## Avolites LTD Engineering Change Notice

ECN title	Sapphire motor fader belt repair		
ECN Number	ECN-0211		
Related Product(s)	All Sapphire Touch console up to ST-0274 All Sapphire fader wings up to STFW-020		
Date / Author	09/05/2015	JB Toby	
Reasons for ECN	Weak clamping of the belt allows for the belt to slip and damage to the belt		
Parts required	RTV Silicone Adhesives, see below for specification Small cable tie to apply adhesive		
Tools required	Tools to remove fader PCB.		
Estimated time	15 Minutes per board once removed from the console A whole console takes up to 3 hours excluding curing time. (PCB remove, inspect and modify faders, PCB replace, test console.

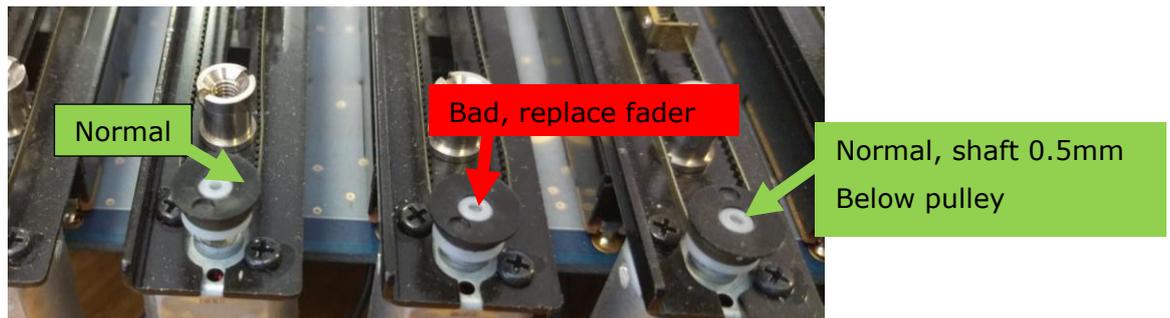
Check that the belt wear is not too long, the maximum damaged belt length is 30mm

2. If the belt is damaged over a length longer than 30mm replace the fader, (See image above)
3. Check that the motor pulleys is not raised more than 1mm above the, normally the shaft is about 0.5mm under the head of the pulley

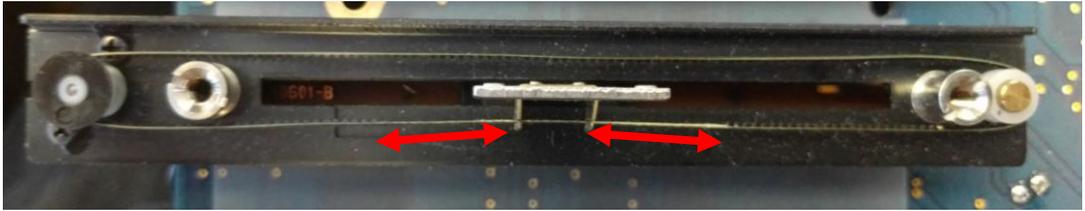
4. Replace the fader if the pulley has moved up

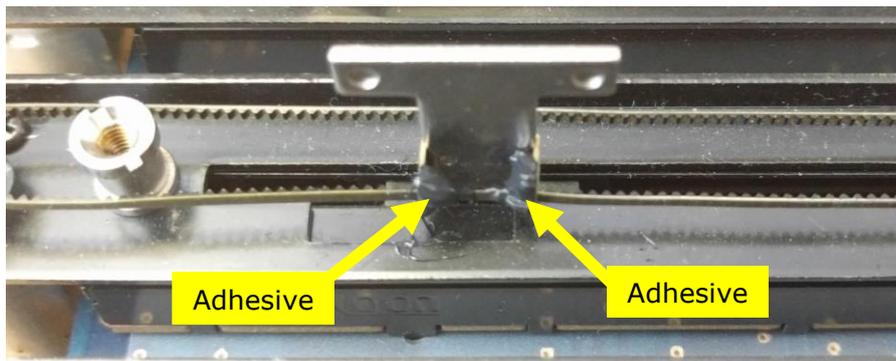
5. Now that all faders have past the initial test, apply the adhesive to all faders as described below;
- A. If the belt has been stripped, place the fader shaft in the centre of the stripped area as shown below

- B. Apply two small dabs (see below for sample size) of adhesive on the **inside** of the fader shaft clamp, make sure to work the adhesive onto the belt as well as the clamp.

Sample size of amount of adhesive, circa 3mm sphere.
